THE SOUTHERN INTERCHANGE AND THE WESTFIELD CYCLING STRATEGY.
19 JUNE 2008

1 SUMMARY

1.1 I find several problems with the design involved with the Southern Interchange and with Westfield's plans for cycling. This paper should be construed as an objection to the planning applications. 2007/02266/FUL, 2008/01417/DET, 2008/01603 DET

2.1 The present plans according to the landscaping application [2008/01603 DET] drawing 424966

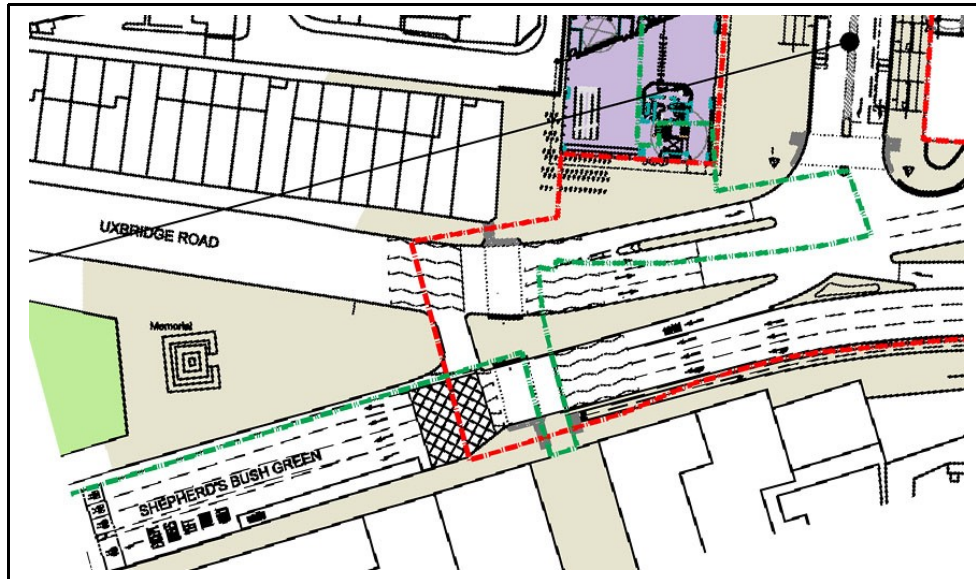
I have outlined the Toucan crossing in yellow. The green arrows represent the paths that cyclists are expected to take. There will also be pedestrians waiting to cross when the traffic is flowing.

The method of leaving a busy carriageway [Uxbridge rd] into and through pedestrians and cyclists waiting to cross on the toucan crossing is to be deplored. The danger of not being able to exit the carriageway because the dropped curb is blocked with waiting pedestrians is excessive. Fast moving buses will be following close behind the cyclist.

4.1 The supporting statement 346703 of the Southern Interchange Application 2007/02266/FUL shows a kerb line that was different from the present configuration. It appears that the developers were using plans that were many years out of date.

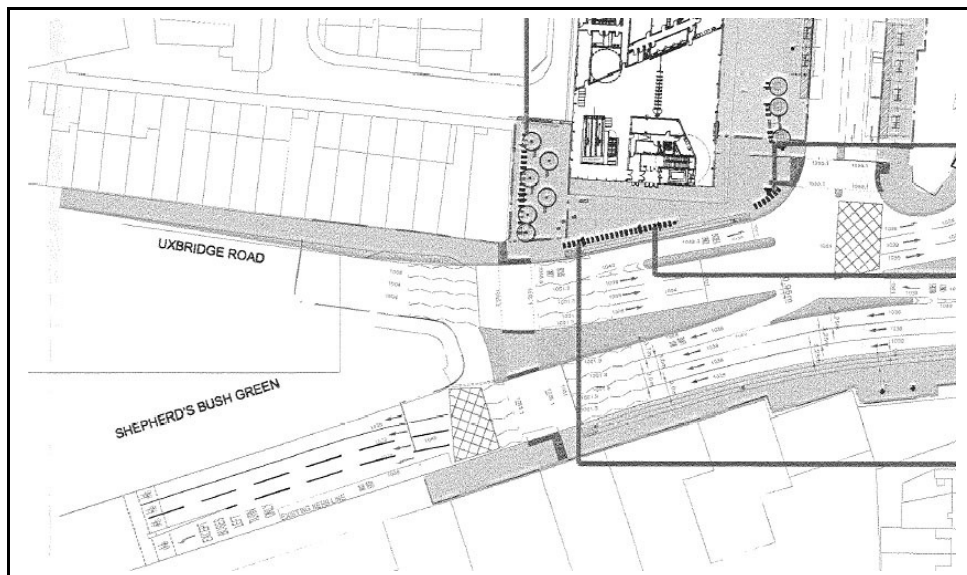
[Note that the red dashed line shows the area of the Southern Interchange application].

[From drawing 420848 that accompanied the application 2008/01417/DET]

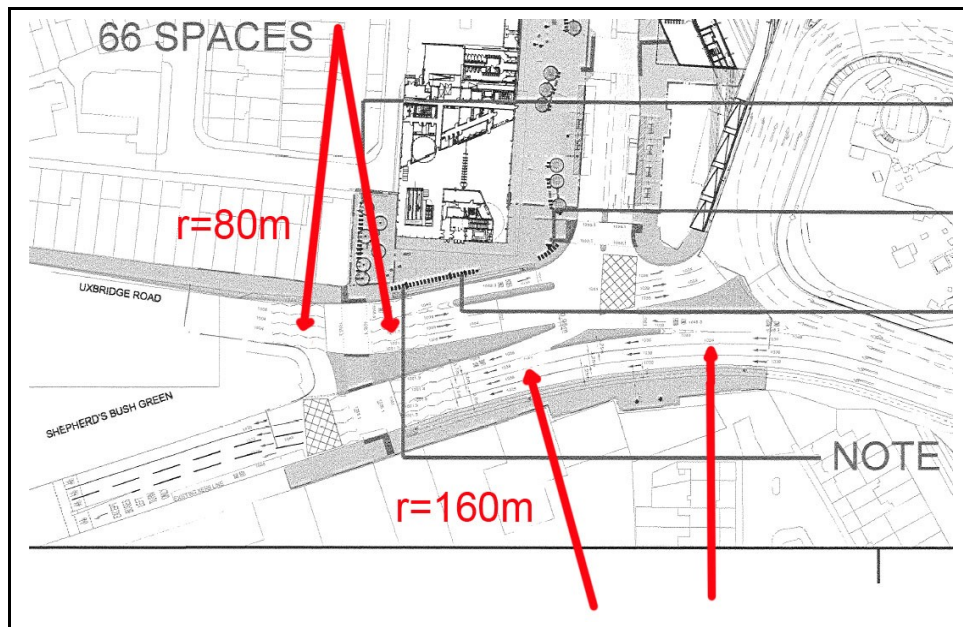
5.1 There are fundamental problems concerning the lane widths on a curve, as a long vehicle on a bend requires a wider lane than normal. The toucan crossing acts as a break between two straight sections of the Uxbridge road. However the geometry actually constitutes a sharp bend in the road, with no lane markings.

5.3 The radius of the curve on the eastbound carriageway of the Uxbridge rd at the Toucan crossing appears to be 80m or less. The DMRB suggests lane widths of 3.8m or 4.0m are in order in such cases.

An example of lanes being wider on a curve: the westbound lanes of Shepherds Bush Green are wider on the curve at 3.25m and narrow to 3.0m as they approach the Toucan crossing. The radius of the curve here appears to be about 160m.

5.4 On the westbound carriageway of Shepherds Bush Green just after the Toucan there is a sudden kink in the lanes, which also may be a problem for long vehicles if the lanes are narrow, and which is partially obscured by road hatchings.

[from drawing 424966 of the landscaping application 2008/01603 DET]

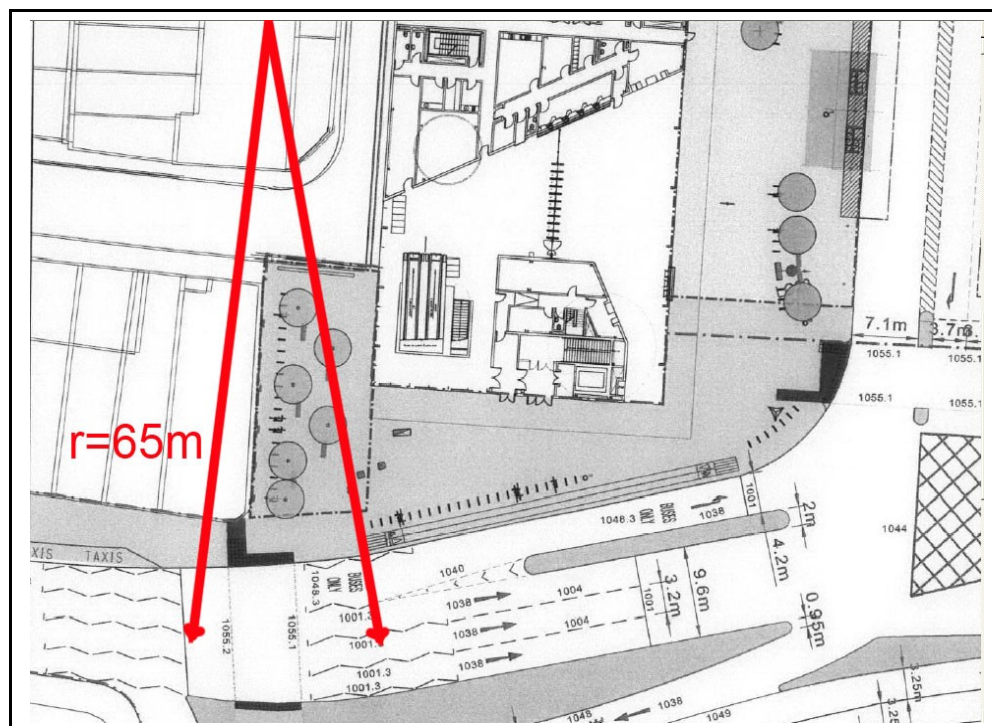
5.5 A more precise drawing suggests the radius is closer to 65m on this bend in the Uxbridge rd. Many cyclists are expected to be on the carriageway passing through this area.

5.6 The Uxbridge road is carrying a lot of HGV's on the narrow lanes that showing no signs of widening on the bend. As the lane markings are obscured by a crossing, this road layout would appear a little dangerous.

Are the lane configurations of the Uxbridge road valid?
